Informação do produto — Calços de travão | HELLA

8DB 355 011-401 / 8DB 355 015-961

Changed brake pads

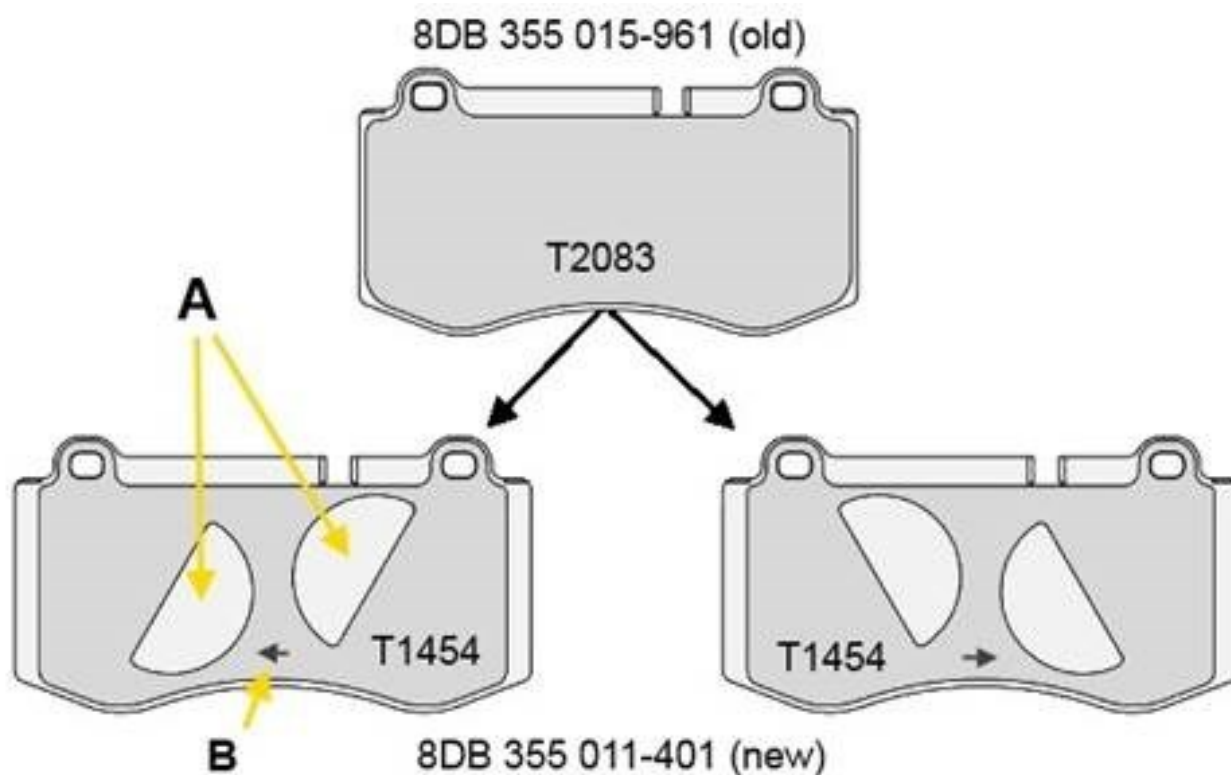
Brake pad 8DB 355 015-961 / T2083 will be replaced by brake pad 8DB 355 011-401 / T1454.

The difference between both brake pads is a change to the damping plate on the back plate of the brake pad. This change improves the noise sensitivity and thus, the comfort properties of the brake pads.

A new driving direction-related installation is necessary for the new damping plate with recess (A). The installation direction is indicated by an arrow (B).

A special assembly instruction is enclosed in every box.
